U.S. Department of the Interior BUREAU OF LAND MANAGEMENT Sundry Print Reports
08/14/2023

Well Name: LLAMA MALL 26-35 Well Location: T22S / R32E / SEC 23 / County or Parish/State: LEA /

### **Notice of Intent**

Type of Action: APD Change

### WELL LOCATION AND ACREAGE DEDICATION PLAT

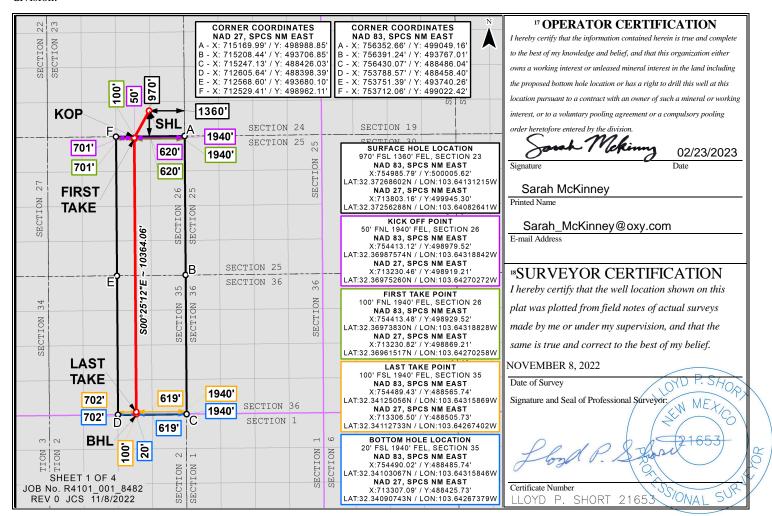
**Procedure Description:** OXY USA INC. respectfully requests approval to amend the subject well AAPD, The Bottom hole location is changing from 20 FSL & 1640 FEL, to 20 FSL & 1940 FEL. The updated plat is attached, along with the Update Drill Plans and Drilling Supporting Documents.

UL or lot no.	Section	Township	Range	Lot Idn	Feet from the	North/South line	Feet from the	East/West line	County
О	35	22S	32E		20	SOUTH	1940	EAST	LEA
12 Dedicated Acres	13 Joint or	Infill 14 C	Consolidation (	Code 15 Or	der No.				
640.0
